**ADDENDUM 1**

- A. Project: Spaulding Building Renovation
- B. Owner: State of North Carolina – Fayetteville State University – Fayetteville, NC
- C. Owner Project Number:
  - 1. SCO ID #: 24-28707-A01
- D. Architect: Studio Archibene, PLLC
  - 1. Architect Project No.: S/A Project Number 2404.00
- E. Date of Addendum: 02 July 2025

**Project 2404.00 - Fayetteville State University Spaulding Building Renovation**

### ROOM IDENTIFICATION SIGNAGE PLAN

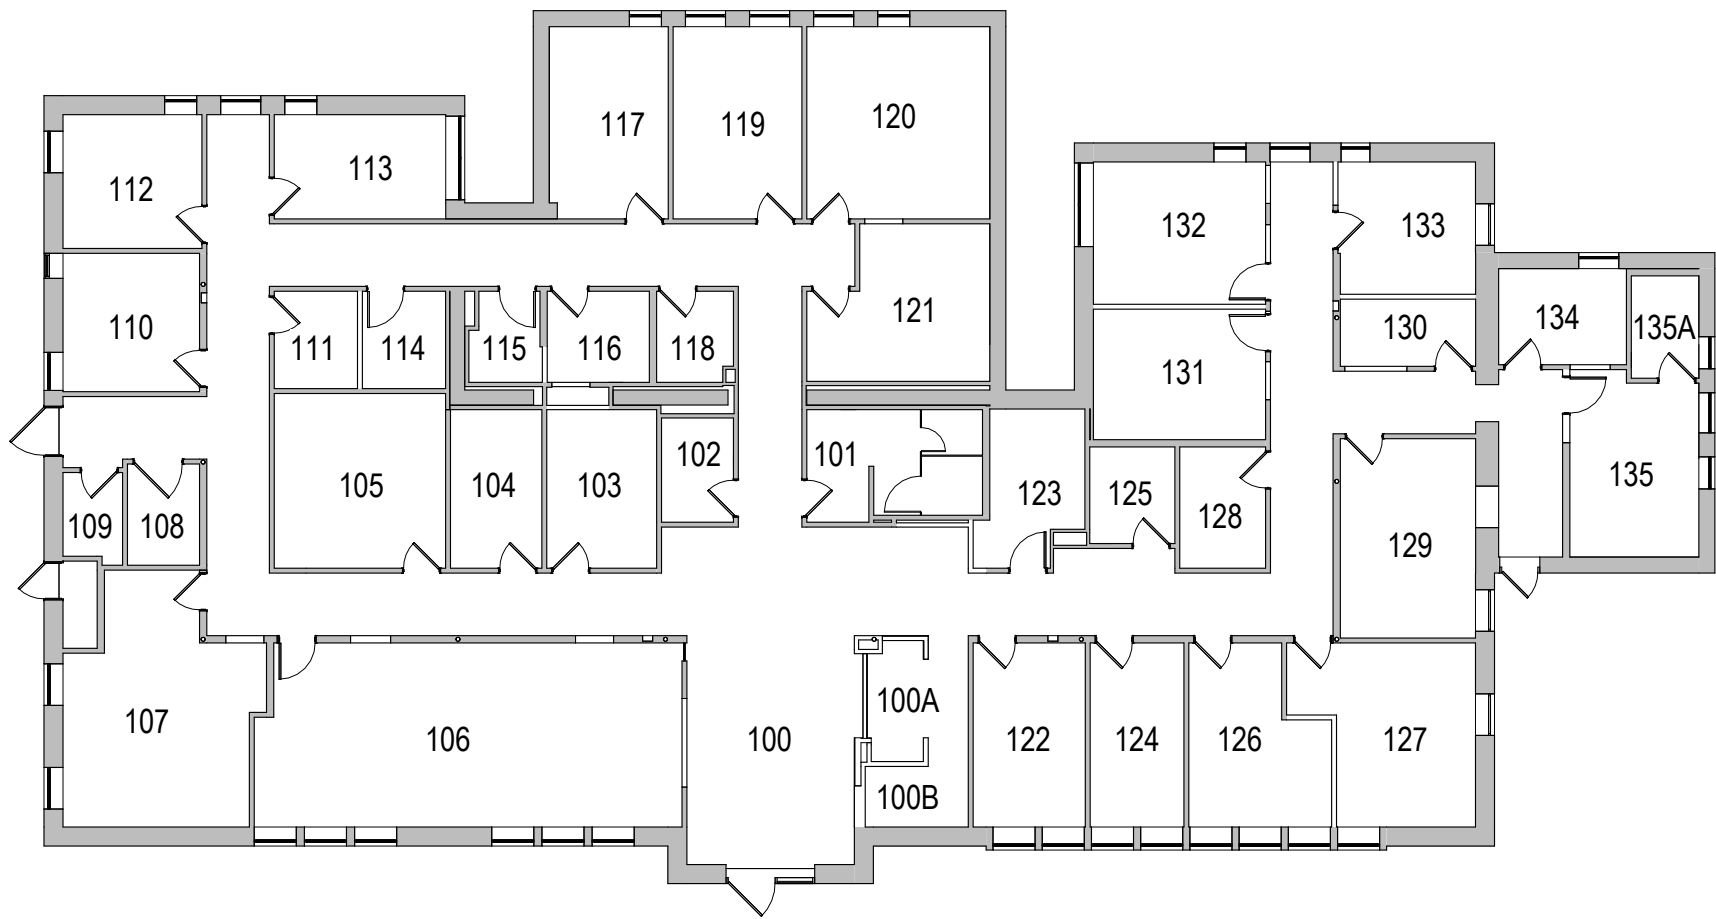
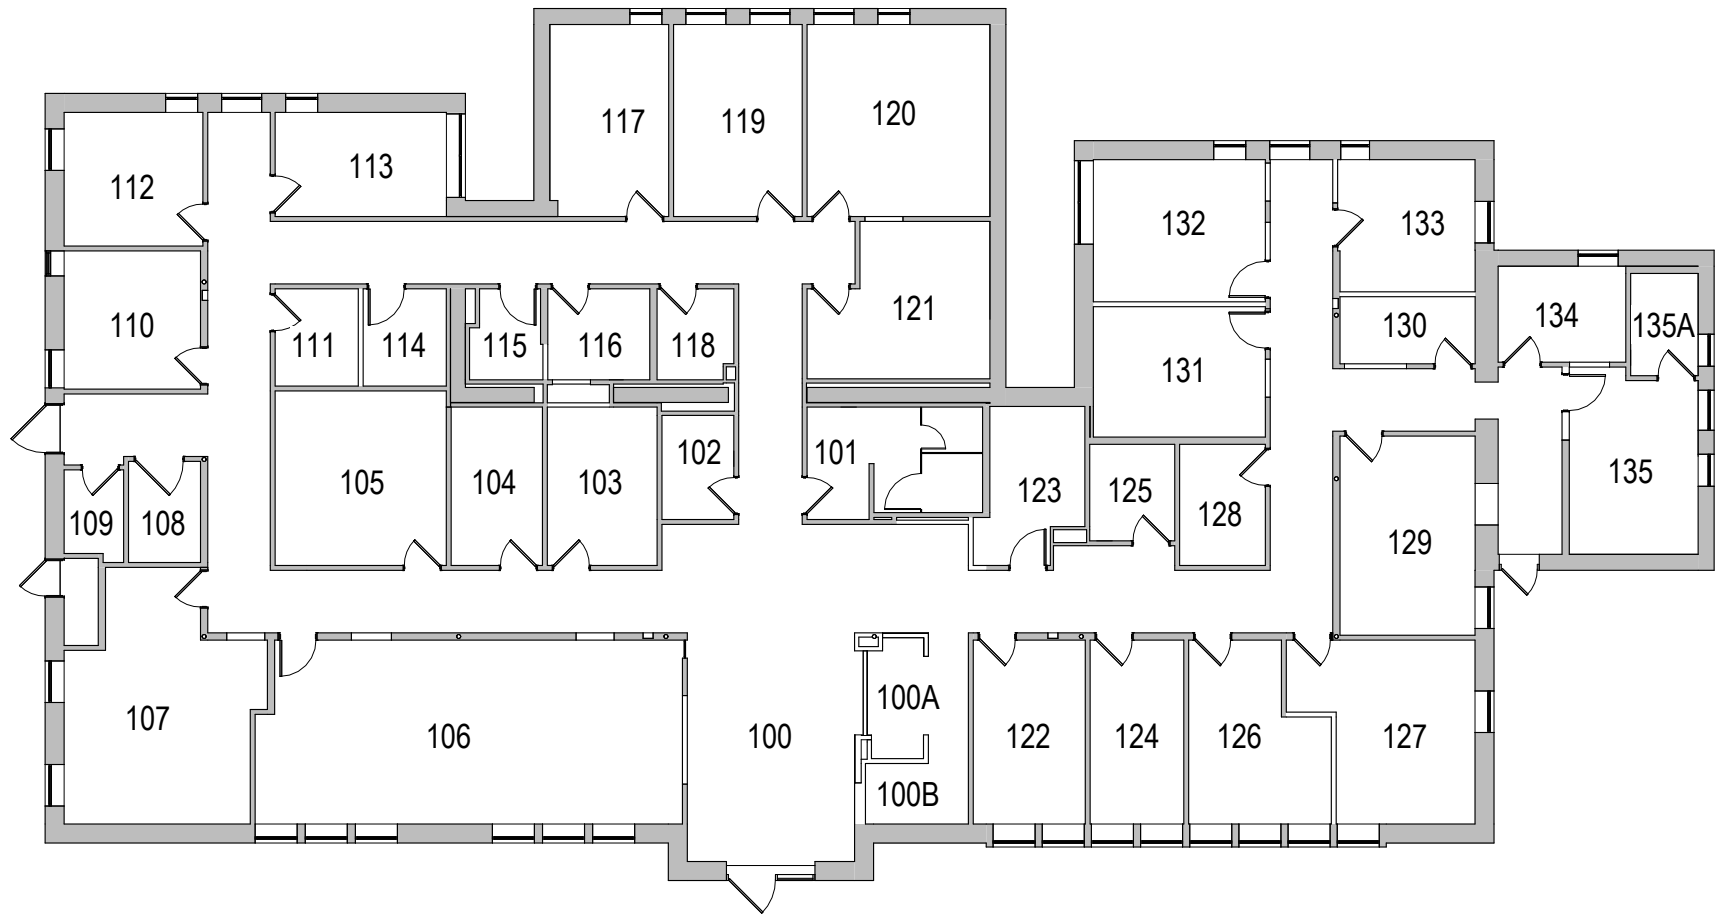
1. ADD Drawing 01 – Room Identification Signage Plan
  2. ADD Drawing 04 – Room Identification Signage Mounting Height
